Item ID: DSI 9410-011 Accept ***N900040100*** Setup Start ***NS1***
 Revision ID: Stop ***NS2***
 Item Name: Step Modification
 Start Date: 7/10/12 Start Qty: 5.00 ***5*** Cust Item ID:
 Required Date: 8/03/12 Req'd Qty: 5.00 ***5*** Customer:
 Reference:

DART SERVICE INSTRUCTION

TO AMEND DRAWING D350-591 REV. F

REF. CANADIAN STC: SH92-6

FIGURE 1 - CLAMP/CUSHION INSTALLATION

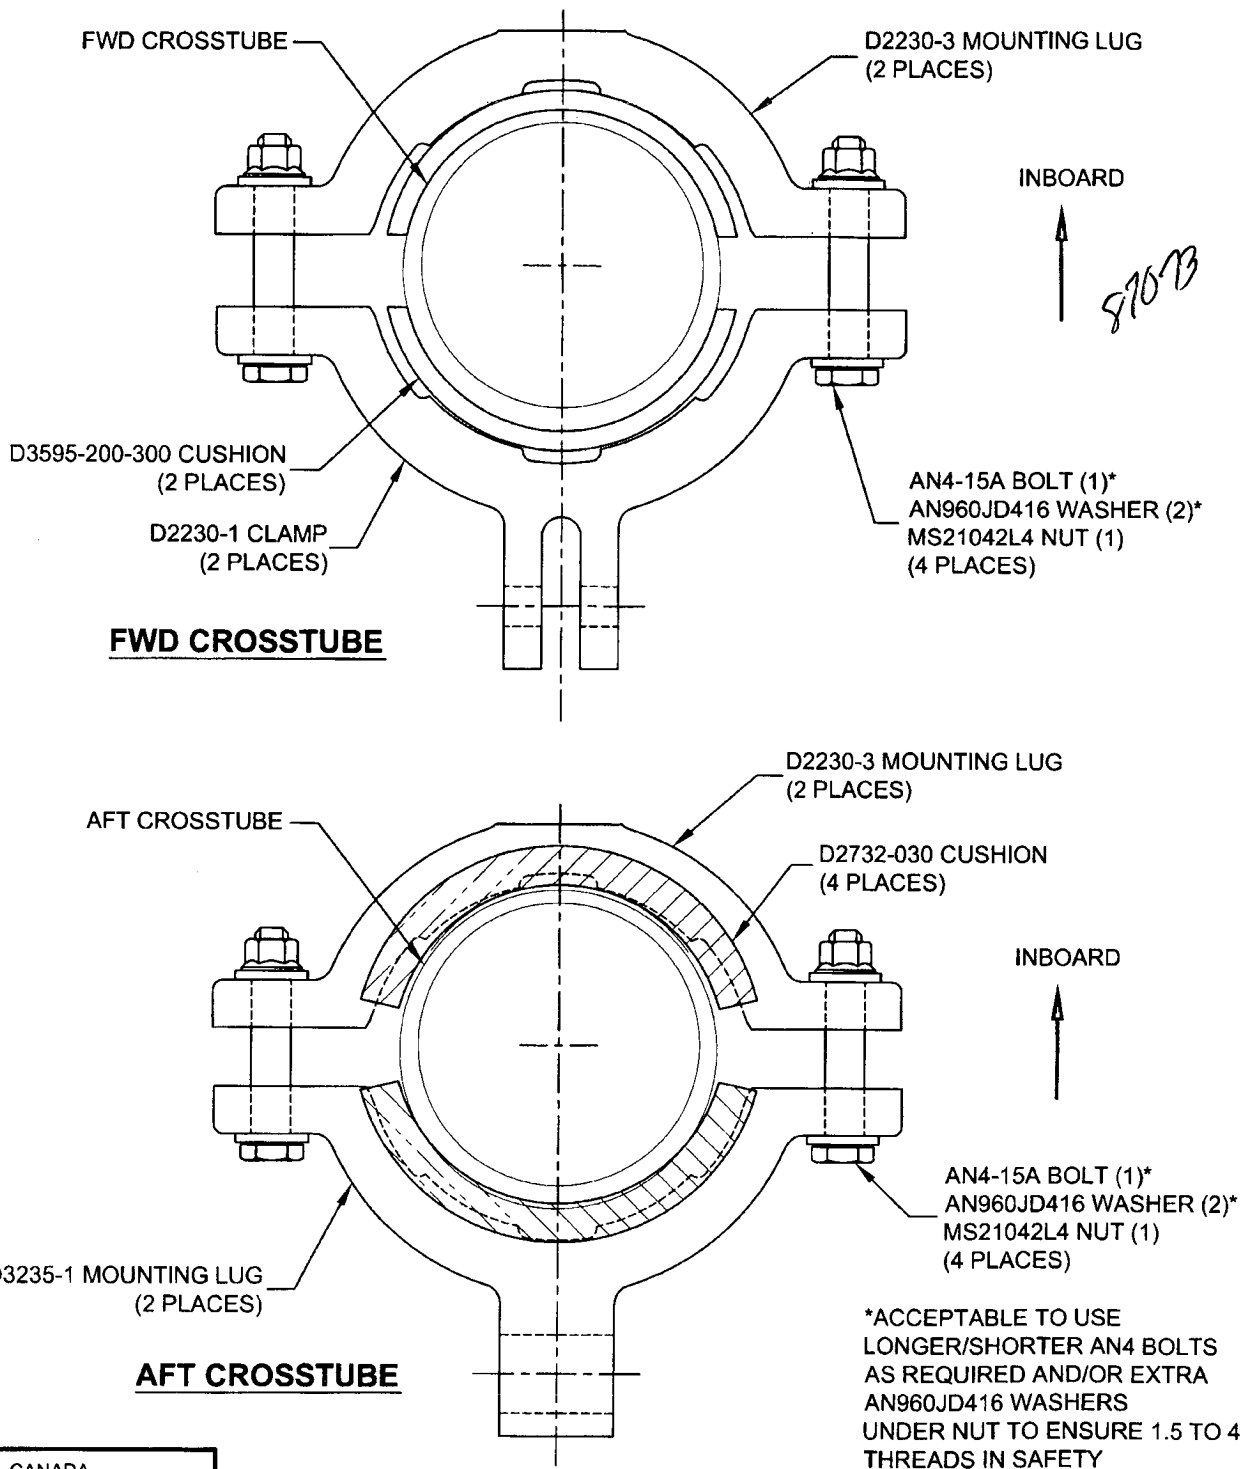
TO IMPROVE THE FIT OF THE D350-591-311/-312 STEPS, IT IS ACCEPTABLE TO INSTALL THE DSI 9410-011 KIT. INSTALL THE D2732-030 CUSHION (AFT CROSSTUBE) AND D3595-200-300 CUSHION (FWD CROSSTUBE) AS SHOWN IN FIGURE 1 IN PLACE OF THE D2856-400-720 ABRASION STRIP CALLED OUT ON DRAWING D350-591 REV. F.

FOR CUSTOMERS WHO HAVE PREVIOUSLY INSTALLED D2856-400-720 ABRASION STRIPS REMOVE THE ABRASION STRIPS IN ACCORDANCE WITH ICA-D350-591. PRIOR TO INSTALLING THE DSI 9410-011 KIT.

FIGURE 1 - CLAMP/CUSHION INSTALLATION

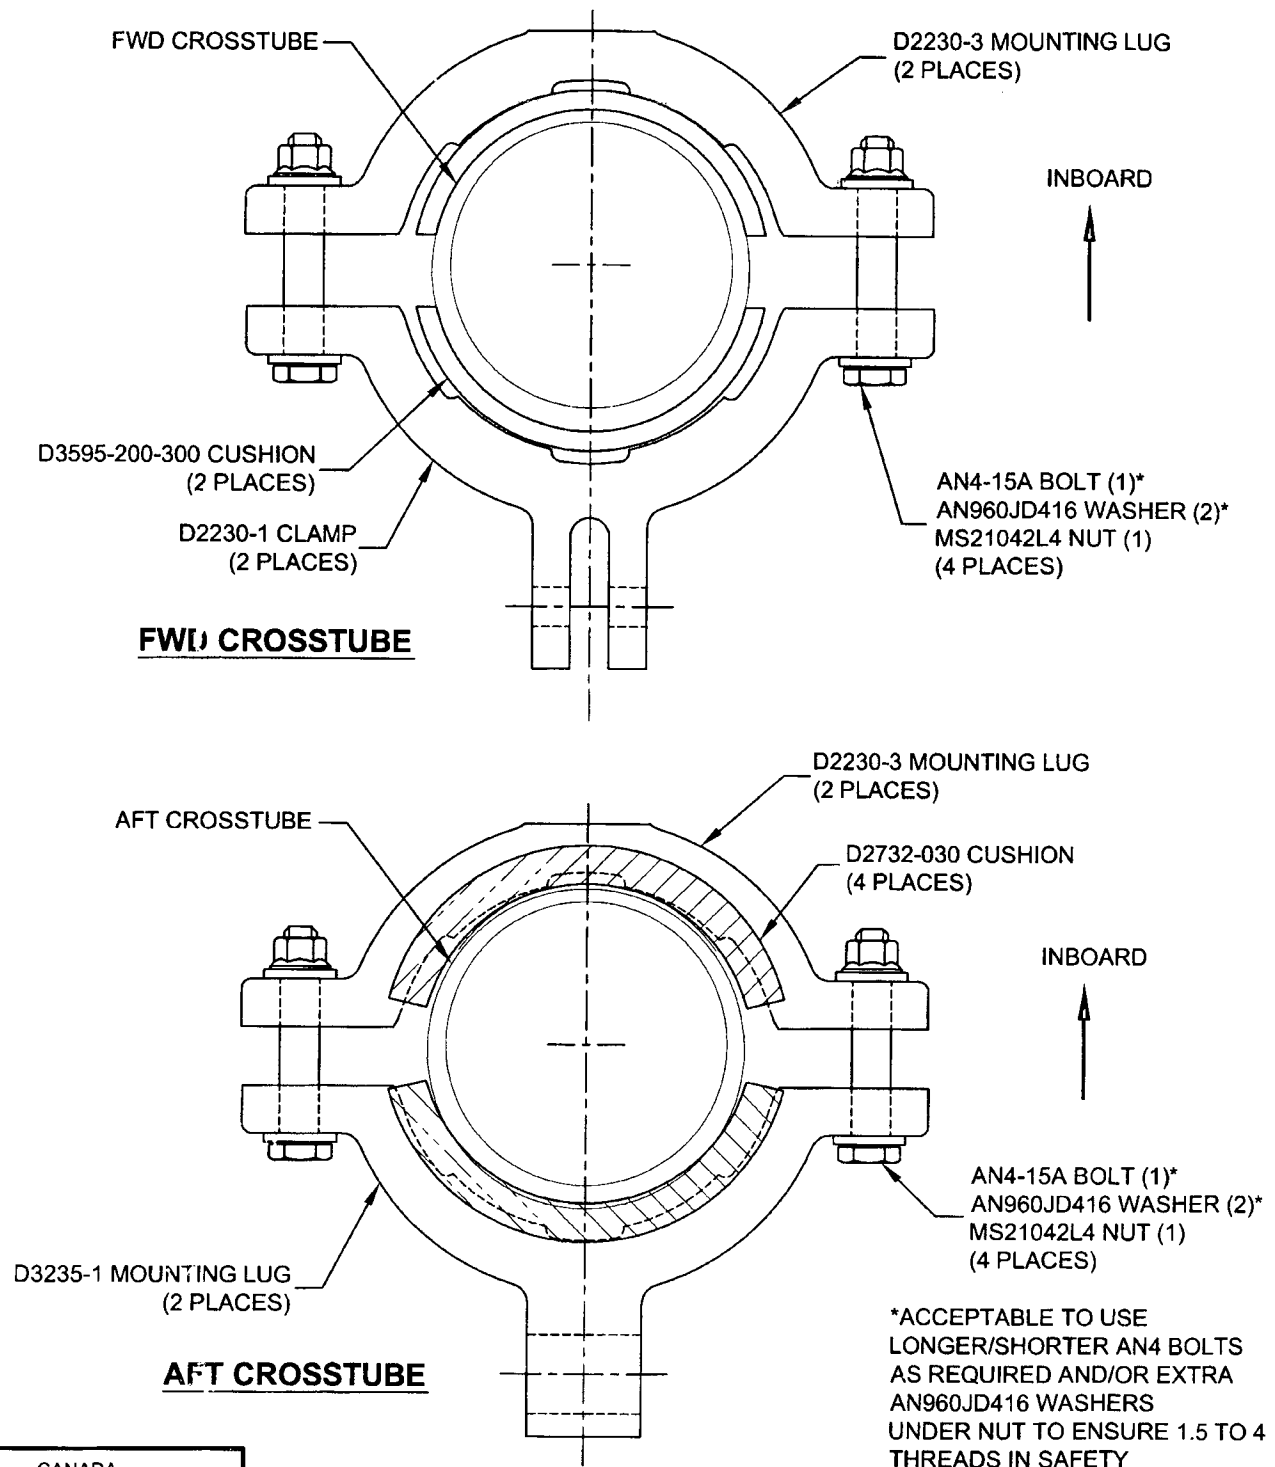
TO IMPROVE THE FIT OF THE D350-591-311/-312 STEPS, IT IS ACCEPTABLE TO INSTALL THE DSI 9410-011 KIT. INSTALL THE D2732-030 CUSHION (AFT CROSSTUBE) AND D3595-200-300 CUSHION (FWD CROSSTUBE) AS SHOWN IN FIGURE 1 IN PLACE OF THE D2856-400-720 ABRASION STRIP CALLED OUT ON DRAWING D350-591 REV. F.

FOR CUSTOMERS WHO HAVE PREVIOUSLY INSTALLED D2856-400-720 ABRASION STRIPS REMOVE THE ABRASION STRIPS IN ACCORDANCE WITH ICA-D350-591. PRIOR TO INSTALLING THE DSI 9410-011 KIT.

FIGURE 1 - CLAMP/CUSHION INSTALLATION

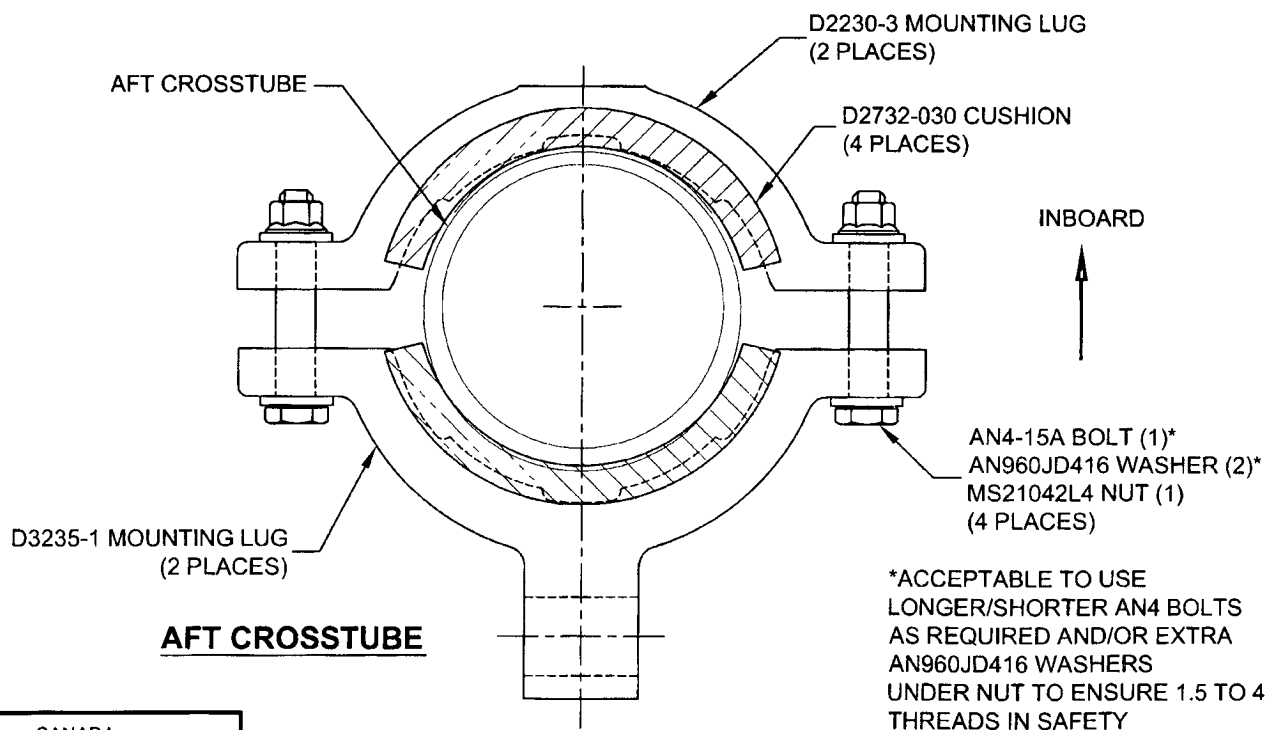
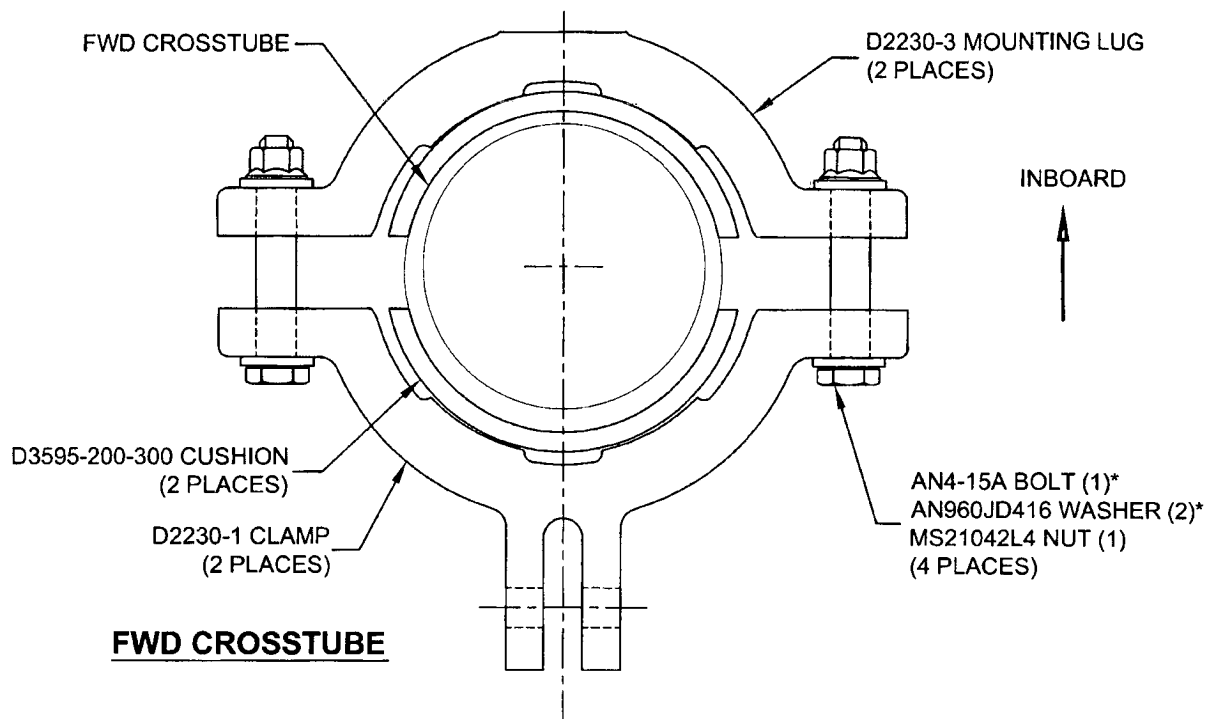
TO IMPROVE THE FIT OF THE D350-591-311/-312 STEPS, IT IS ACCEPTABLE TO INSTALL THE DSI 9410-011 KIT. INSTALL THE D2732-030 CUSHION (AFT CROSSTUBE) AND D3595-200-300 CUSHION (FWD CROSSTUBE) AS SHOWN IN FIGURE 1 IN PLACE OF THE D2856-400-720 ABRASION STRIP CALLED OUT ON DRAWING D350-591 REV. F.

FOR CUSTOMERS WHO HAVE PREVIOUSLY INSTALLED D2856-400-720 ABRASION STRIPS REMOVE THE ABRASION STRIPS IN ACCORDANCE WITH ICA-D350-591. PRIOR TO INSTALLING THE DSI 9410-011 KIT.
